**AQUA-LUNG®**  
A DIVISION OF U. S. DIVERS CO.

## REGULATOR RECALL

SUBJECT: INSTALLATION INSTRUCTIONS FOR THE 1070-10  
CALYPSO HIGH PRESSURE SEAT AND BUSHING KIT

FIGURE 1

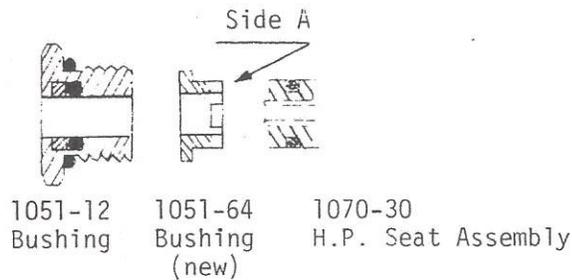
As you know from our telegram, we have discovered that there may be a potential problem with our 1083 and 1084 Calypso regulators. It is possible for the high pressure seat located in the first stage of the regulator to move from its normal position and restrict or completely shut off the air flow to the diver. Should this occur, diving with the regulator would be extremely hazardous. Please advise your customers that they should not use these regulators until they have been retro-fitted with a special new bushing.

We will institute a repair program whereby we will automatically send a quantity of new bushings to all accounts. The installation of these new bushings will eliminate the potential problem. Each bushing will be accompanied by a maintenance record in the form of a postcard. This card will be self-addressed to U.S. Divers and will require information including the regulator serial number and the date of retro-fitting. When the bushings are sent out, there will be a \$1.00 charge for each. Upon notification by receiving the postcard, we will issue \$4.00 to your account, thus you will be paid \$3.00 to make the repairs. Any unused bushings may be returned upon notification of the termination of this program for credit against the \$1.00 charge.

15. Installation of the new bushing (P/N 1051-64) is then most easily accomplished by utilizing a suitable diameter wood or metal shaft. (The Allen screwdriver used to turn the adjustment nut is a suitable tool.)

Insert the shaft through the new bushing and then place the new bushing with side A against the H.P. seat. See Figure No. 1 on next page. Care should be taken not to scratch the surface of the seat with the shaft.

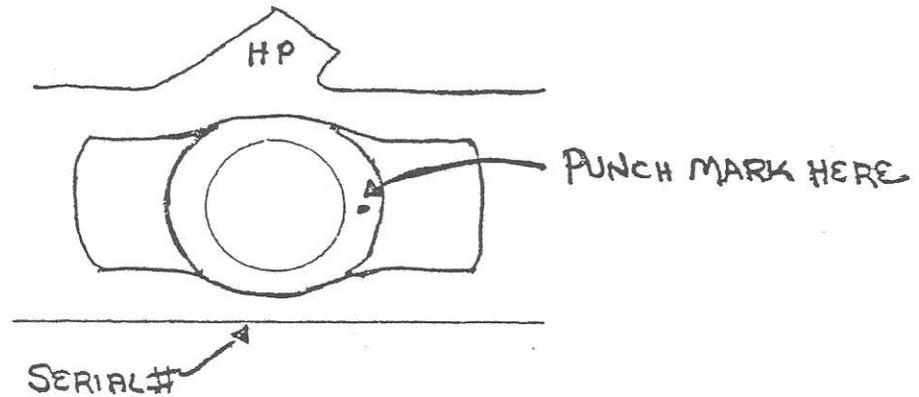
In compliance with recall standards we ask your cooperation in identifying the retro-fitted Calypso's. Effective this date, any regulator retro-fitted under the recall should show the external, identifying punch-mark indicated on the attached drawing. ALL Calypso models, 1048, 1070, 1071, 1083, and 1084 shall be so marked upon retro-fit with one exception. That is, any new production since November, 1979 that shows a first stage serial number beginning with "0" will not be punch-marked. These units were updated in production and there is no other exception. We have made a direct mailing to those from whom we have received a retro-fit certification card. This card indicates the serial number of the unit retro-fitted and requests that they allow their Aqua-Lung Dealer to punch-mark the yoke on their next visit to the shop. They are asked to present the card with the regulator for the quick and easy ID.

LOOKING DOWN ON THE YOKE, WITH THE SERIAL DOWN & THE HP PORT UP, MAKE PUNCH MARK AS INDICATED.

SHOULD THE REGULATOR NOT HAVE A SERIAL#, IT STILL HAS A HP PORT WITH WHICH YOU MAY LINE UP THE PUNCH MARK.
